**Report by the Mining & Petroleum Gateway Panel
to accompany a Conditional Gateway Certificate
for the Bylong Coal Project**

15 April 2014

The Mining & Petroleum Gateway Panel (the Gateway Panel) has determined an Application for a Gateway Certificate by KEPCO Bylong Australia Pty Limited (the Applicant) for its proposed Bylong Coal Project in the Upper Hunter region of New South Wales (NSW). The Gateway Panel finds that the Application does not meet the Relevant Criteria and has decided to issue the Applicant with a Conditional Gateway Certificate. This report states the reasons for the formation of the opinions in the certificate.

Figure 4. Equine CIC within the Project Boundary area (after Hansen Bailey, 2014)

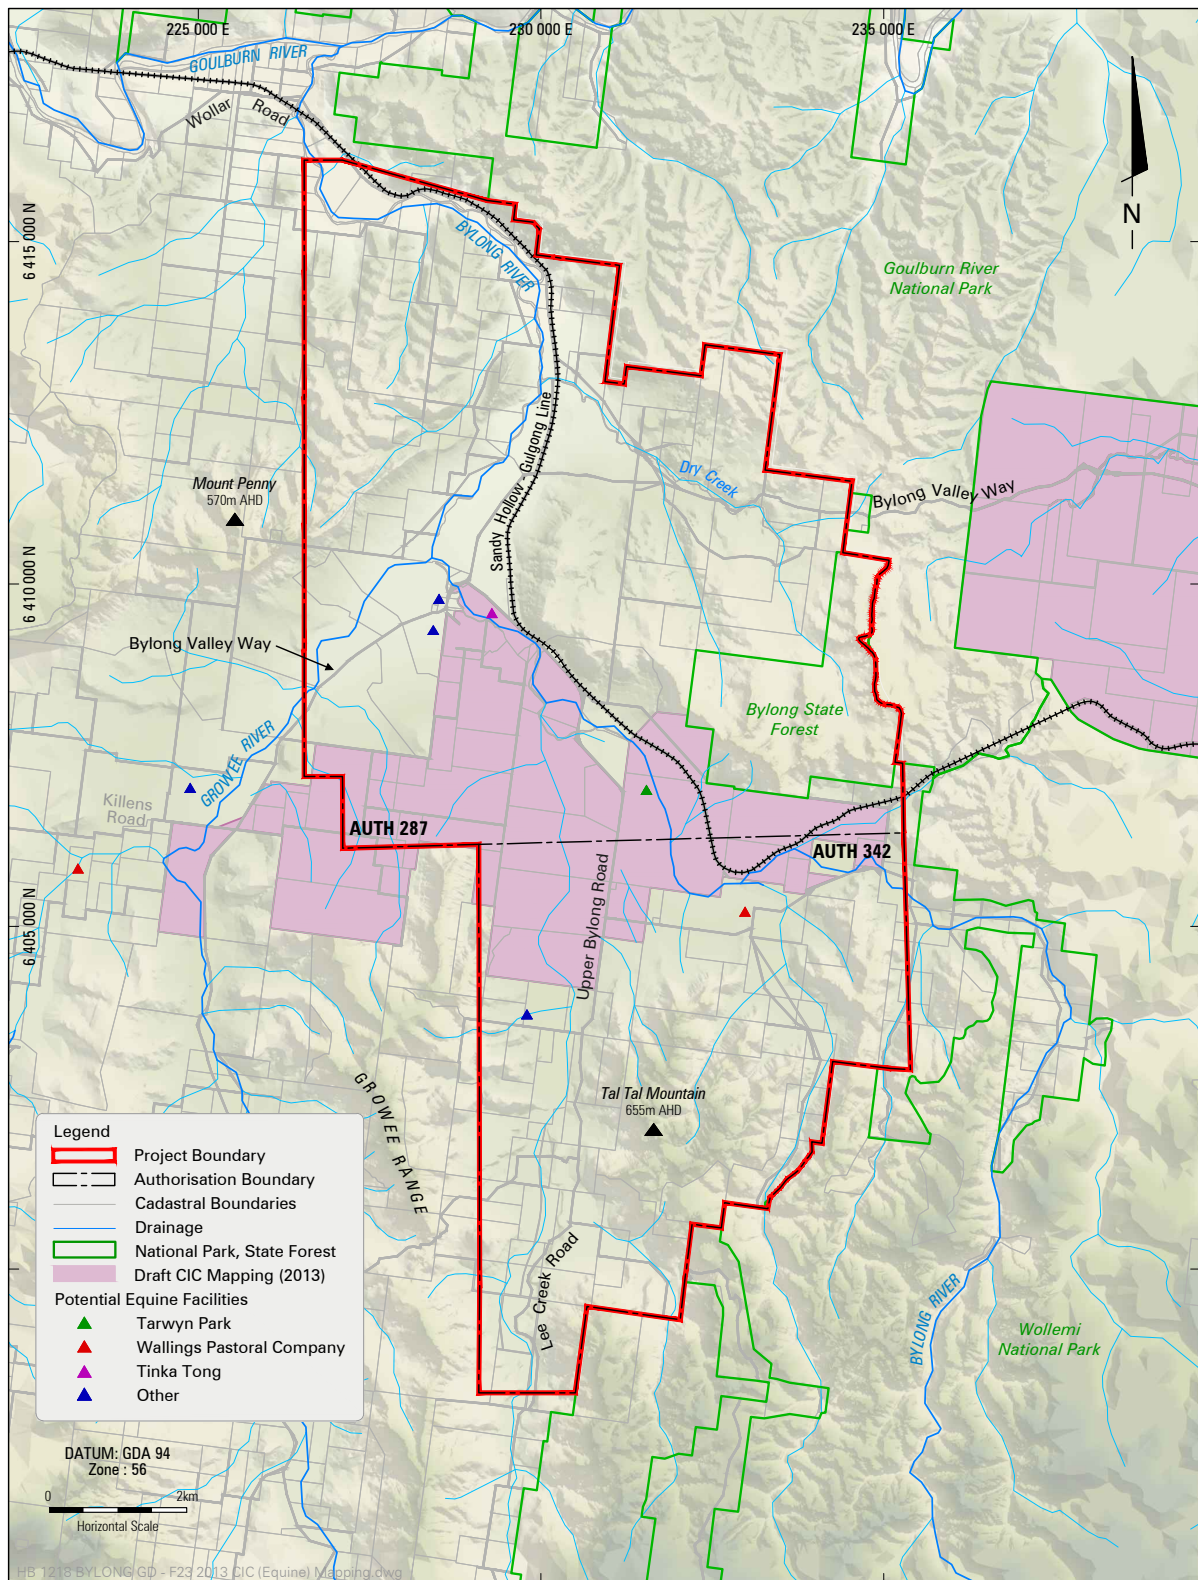
With regard to Equine CIC land, Hansen Bailey (2014) proposes that there are errors in both the DP&I (2012a) and Mining SEPP Critical Industry Cluster Land Map Sheet CIC_001 mapping. Hansen Bailey (2014) concludes that there is no Equine CIC land relevant to Project and therefore, no requirement for assessment of potential impacts.

The Applicant has relied upon the interim verification protocol as reason to dispute draft- and Government-verified mapping of the Equine CIC land within the Project Boundary (Barnett, 2013; Hansen Bailey, 2014). It is the view of the Panel, that this is incorrect application of process because:

- The Applicant did not lodge a Verification Application to Planning & Infrastructure;
- The Interim Verification Protocol is now obsolete and can no longer be used; and,
- Verification of Equine CIC land was never a component of the Gateway process.

Figure 5. Verified BSAL (2,366 ha) within the Project Boundary area (after Hansen Bailey, 2014)

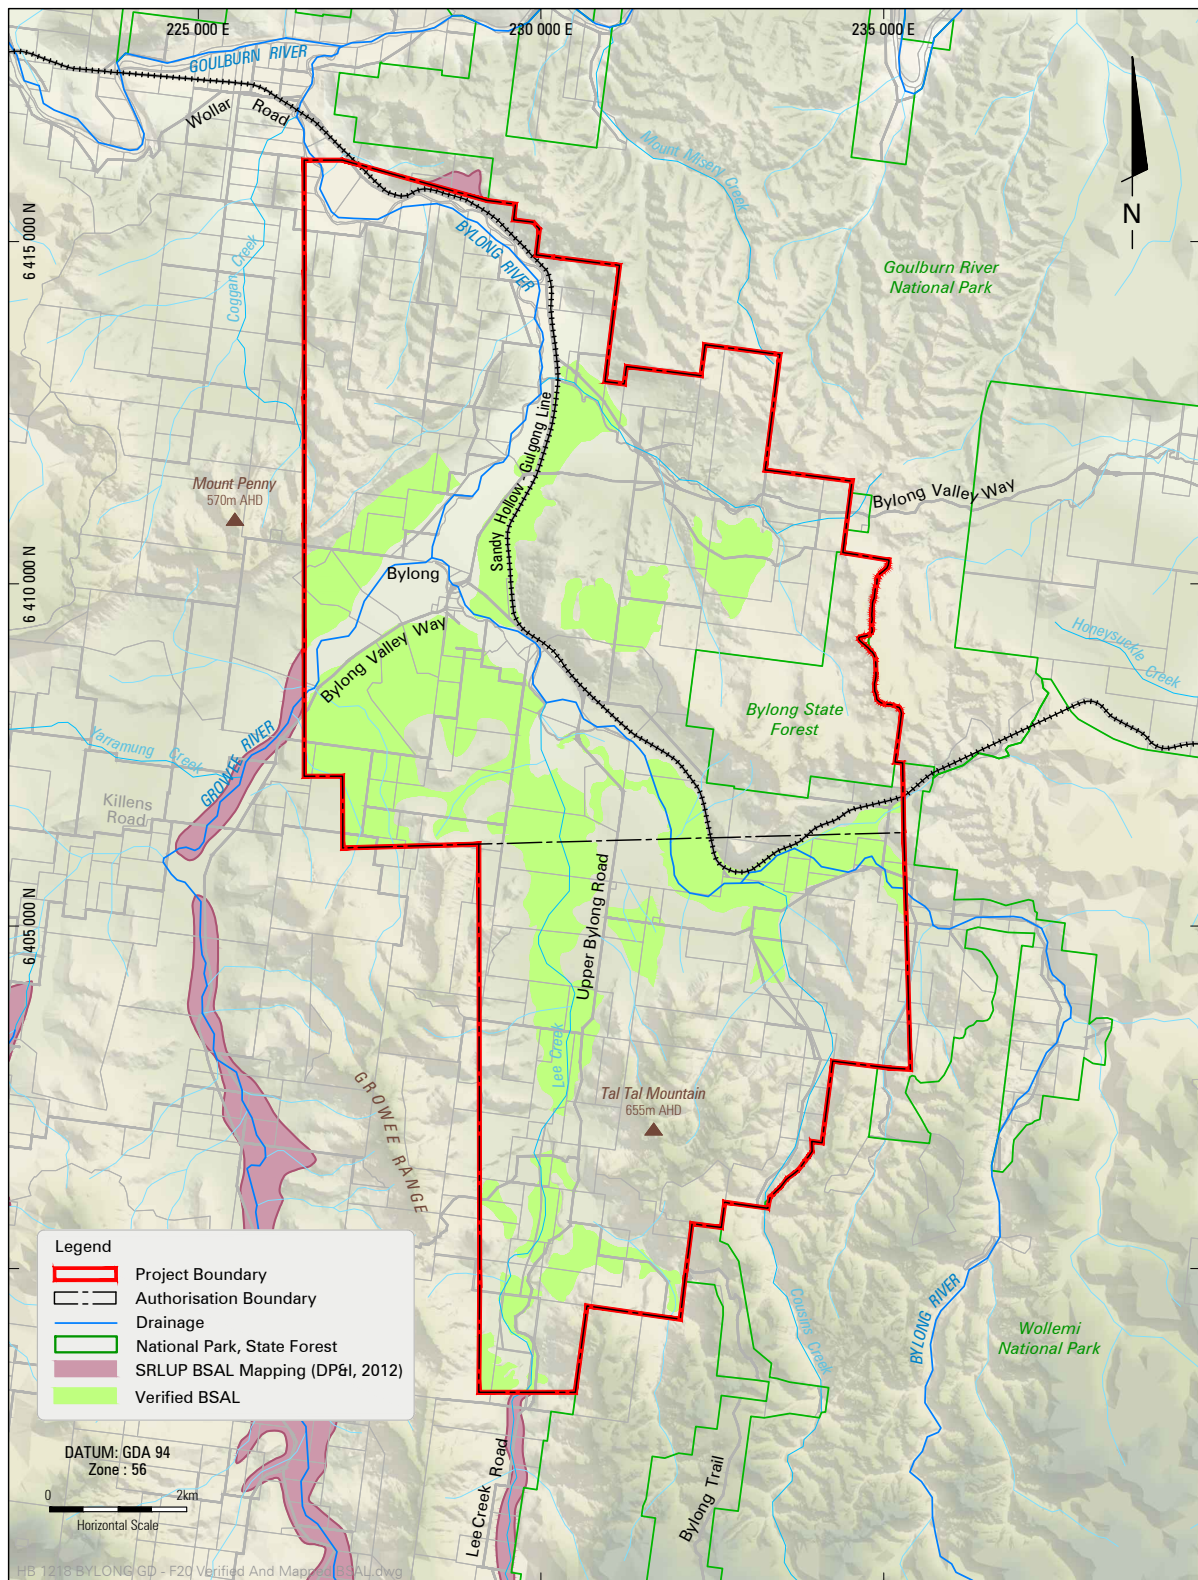
According to Hansen Bailey (2014) however, there is 2,366 ha of verified BSAL soils within the Project Boundary (Figure 5) and 367 ha of these will be impacted by the Project (Table 1). Inconsistently, SLR (2013a and 2013b) and Barnett (2013) discuss potential impacts to 401 ha of verified BSAL soils.

SLR (2013a and 2013b) concludes that 401.3 ha of verified BSAL would be impacted by the Project. In contrast, Hansen Bailey (2014) state the area impacted is 367 ha. The Panel surmises this inconsistency is likely associated with the area of verified BSAL affected by subsidence, i.e. 187 ha in SLR (2013a and 2013b) and 152 ha in Hansen Bailey (2014). Notwithstanding that the error amounts to a relatively small area of about 34 ha, this inconsistency frustrates assessment.
